Official Transcript of Proceedings NUCLEAR REGULATORY COMMISSION

Title:	Advisory Committee on Reactor Safeguards
Docket Number:	(n/a)
Location:	Rockville, Maryland
Date:	Thursday, February 5, 2015

22	evaluation report now for NINA, combined operating
23	license for South Texas, for a while, since March of
24	2010. The proposed STP Units 3 and 4 will be a
25	certified ABWR design with certain departures. The
I

South Texas Project Site

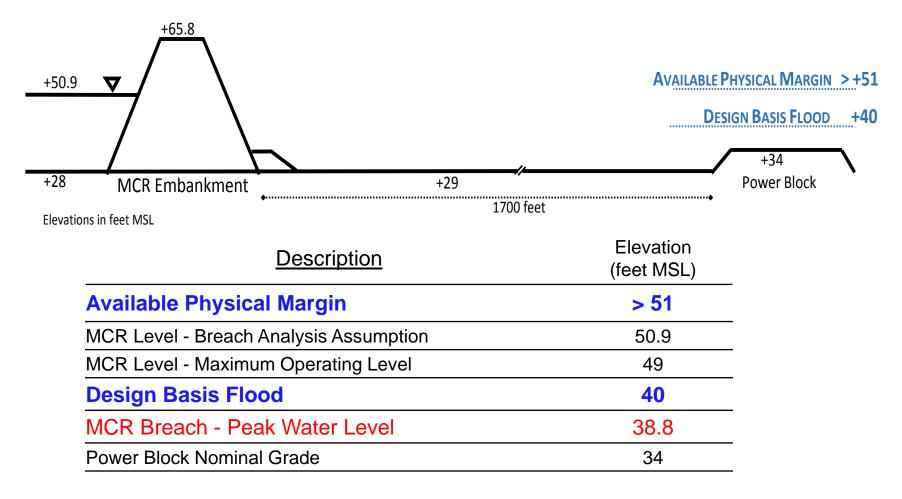
14
1	MEMBER CORRADINI: It was just a question.
2	CHAIRMAN STETKAR: I little defensive, are
3	we?
4	MR. HEAD: So 3 and 4 will be located over
5	in this area, and the switchyard will be for 3 and
6	4 will be like over in this area. And so the design
7	basis flood is developed for us by assuming a breach
8	in this location directly, you know, ultimately
9	downstream from the 3 and 4 location. And for this
10	analysis we used an equation that would develop the
11	ultimate breach size, and then we used another
12	equation to develop the breach time, and with that
13	information we factored it into another equation that
14	would define the outflow, and then that led into
15	another equation that or calculation that defined
16	the flood level as it went towards the site.
17	MEMBER CORRADINI: Just to be clear
18	MR. HEAD: Sure.
19	MEMBER CORRADINI: as I remember, these
20	are typical analyses that are I don't want to say

ESF Logic and Controls System (ELCS) Block Diagram

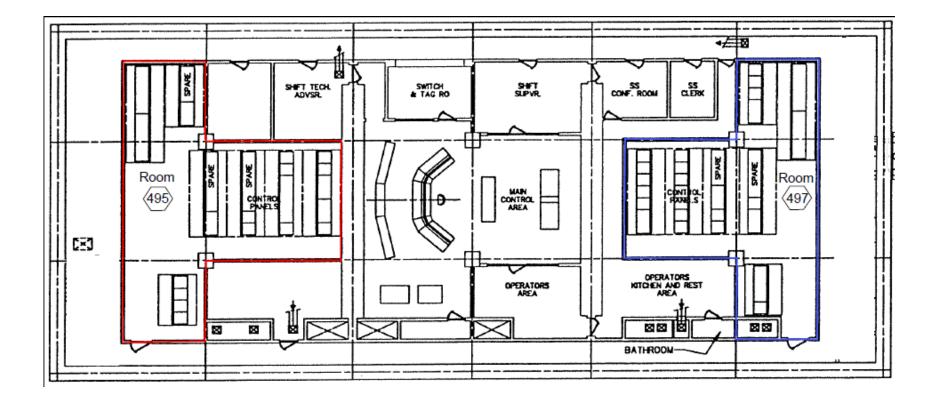
89
1	CHAIRMAN STETKAR: No, not you're still
2	thinking about a clean fire that does not have any
3	signals. I'm talking about a fire that generates a
4	large number of spurious signals, so you have valves
5	opening and things starting and things stopping and
6	valves closing and all of those things. It's not a
7	clean fire; it's a dirty fire.
8	MR. ANDRUKAT: I don't see this as
9	necessarily that different than an analog control
10	fire.
11	CHAIRMAN STETKAR: No, it isn't. That's
12	my question. But why is that if I have analog
13	if that room contained copper cables and analog signal
14	cabinets, NEI 00-01, because it contains copper cables
15	would say I need to look at spurious signals there,
16	because NEI 00-01 is focused on spurious signals from
17	shorts in cabling, right?
18	MR. ANDRUKAT: Correct.
19	CHAIRMAN STETKAR: Okay. But this
20	particular room doesn't contain those copper cables.
21	It does contain those cabinets.

22	MR. ANDRUKAT: Correct.
23	CHAIRMAN STETKAR: So now I don't have to
24	consider those spurious signals because miraculously
25	the fiber optic cables are not copper cables and it's
I	I

90
1	not covered in NEI 00-01, so I don't need to think
2	about the cabinets apparently. My question is:
3	suppose I get a bunch of spurious signals from those
4	cabinets, sending out signals through intact intact
5	fiber optic cables, causing things to operate in ways
6	that I haven't thought about? How do I have
7	confidence that the operators can mitigate that? Not
8	knowing what's operating or what the timing of what
9	is happening in the plant, because I haven't looked at
10	it. I'm not saying that they won't be able to. I'm
11	just saying that nobody has looked at it.
12	MR. DIAZ: This is Antonio Diaz from NRO.
13	My understanding is, even if this was not a fully
14	developed fire, I understand if it was inside a
15	certain cabinet, equipment cabinet, there are
16	temperature monitors that would cause alarms to go
17	off. I also imagine if there is a fire, a high energy
18	fire monitors, again, would be notifying the operators

92
1	any other portion of the plant. And I'll just
2	MEMBER CORRADINI: I'm kind of deferring
3	to John and Dennis about this, because I just don't
4	have the technical background. But the logic you just
5	presented leads me to say that the staff would if
6	this was all copper wire, would essentially approve
7	this as designed, fiber optic or no fiber optic. Is
8	that true? That's what I think Dennis is asking. Am
9	I missing something?
10	MR. ANDRUKAT: Correct.
11	CHAIRMAN STETKAR: Approve the fact that
12	they have not looked at multiple spurious signals from
13	fires in that area. If this fire area contained
14	analog signal cabinets and only copper wire, would the
15	staff approve the fire hazards analysis that does not
16	look at multiple spurious signals from fires in this
17	area, under Reg Guide 1.189? Would you, yes or no?
18	MR. ANDRUKAT: We would follow the NEI 00-
19	01 guidance for this.
20	CHAIRMAN STETKAR: But NEI 00-01 guidance

21	says that I need to look at spurious signals, doesn't
22	it, for fires that affect copper cables?
23	MR. ANDRUKAT: Correct.
24	CHAIRMAN STETKAR: Okay.
25	MR. ANDRUKAT: I would like to add that,
I	1

Division 2 and 4 panels are located in Rm No. 495 Division 1 and 3 panels are located in Rm No. 497
